RE: Salinas Valley – 180/400 Foot Aquifer Subbasin (No. 3-004.01) – 2025 Periodic Review – Additional Information Request

180/400-Foot Aquifer Subbasin 2025 Periodic Review Additional Information

Basin No. 3-004.01

Seawater Intrusion – Advancement

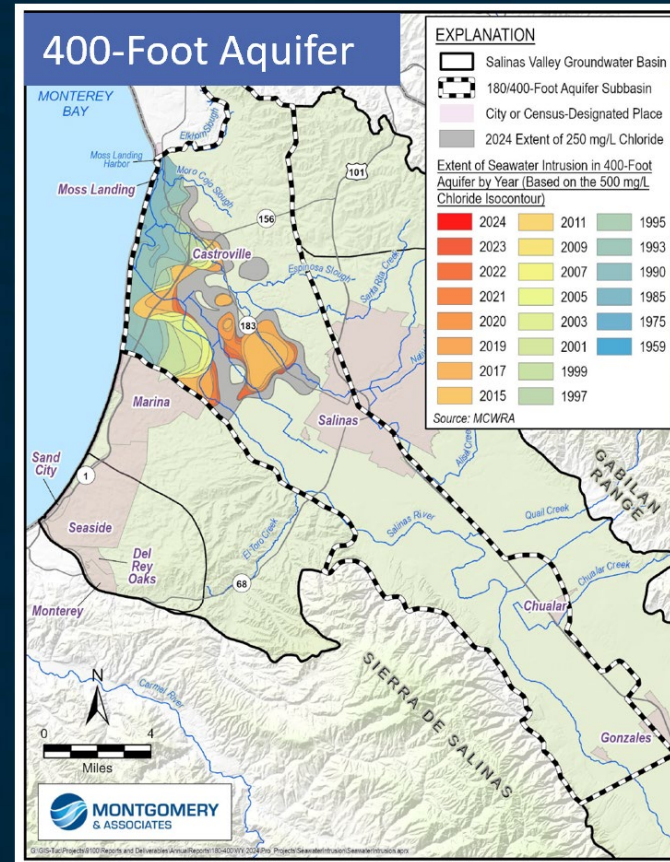
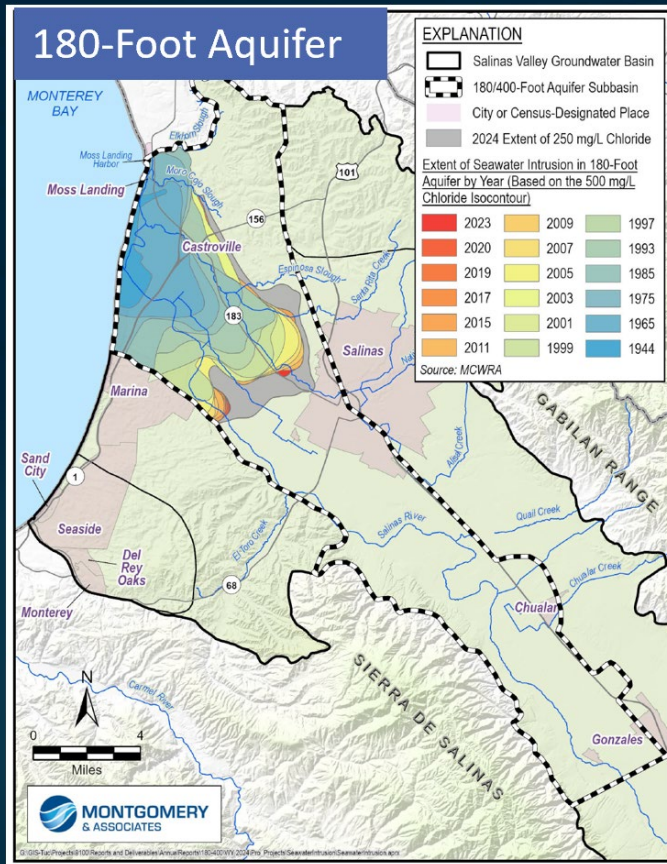
- ▶ 180-Footer Aquifer – SWI advanced during 2019, 2020, and 2023.
 - ▶ 400-Footer Aquifer – SWI advanced every single year since the GSP was implemented.

- ▶ Mapped extent of SWI is based on the 500 mg/L chloride concentration iso-contour.
 - ▶ MT is defined as extent of the 500 mg/L chloride concentration iso-contour observed in 2017. Undesirable result (UR) is defined as intrusion beyond the 2017 extent.

- ▶ SWI is due mostly to groundwater level (GWL) declines from increased GW extraction (2025 Periodic Evaluation, Appendix 3C).
 - ▶ Extent of 250 mg/L chloride iso-contour serves as an early warning of SWI – has reached western boundary of the City of Salinas in the 180-Footer Aquifer and is 990 ft away in the 400-Footer Aquifer.

- ▶ Aquifers in Subbasin: 180-Footer Aquifer, 400-Footer Aquifer, and Deep Aquifers.
 - ▶ Based on information in documents submitted by the SVBGSA, seawater intrusion (SWI) continues to advance in the 180-Footer and 400-Footer Aquifers. No SWI observed in the Deep Aquifers.
